**AMENDMENTS TO THE DRAWINGS:**

FIG. 1

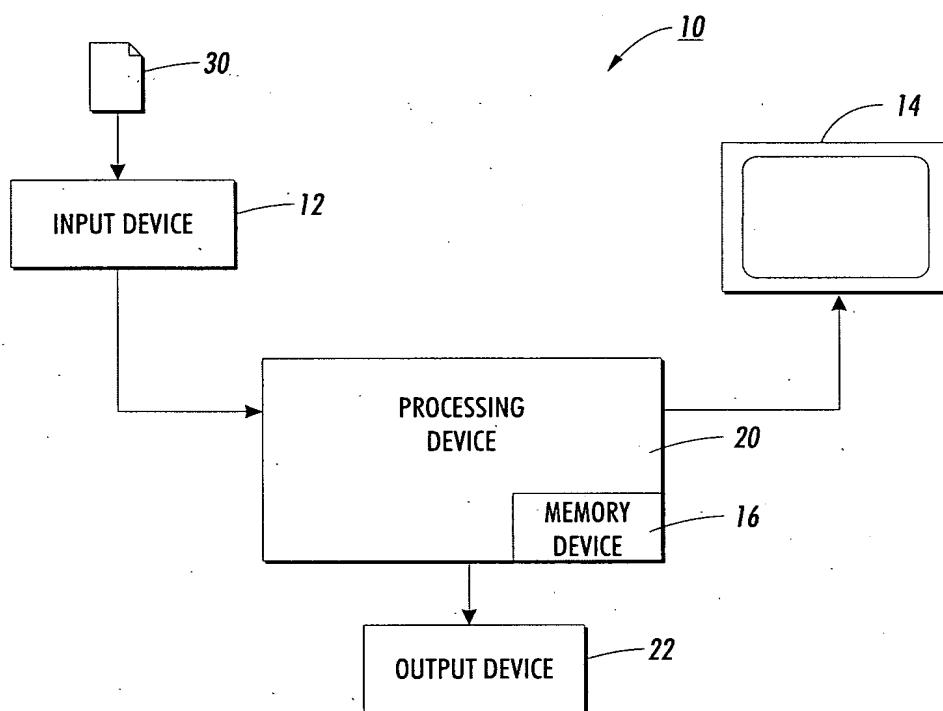
The attached replacement sheet of drawings includes changes to FIGURE 1. This sheet, which includes FIGURE 1, replaces the original sheet including FIGURE 1. In FIGURE 1, the Examiner objected to the drawing because elements 20 and 16 were not labeled as "processing device" and "memory device" respectively. FIGURE 1 has been amended to correct this informality, and Applicants respectfully request that the objection be removed.
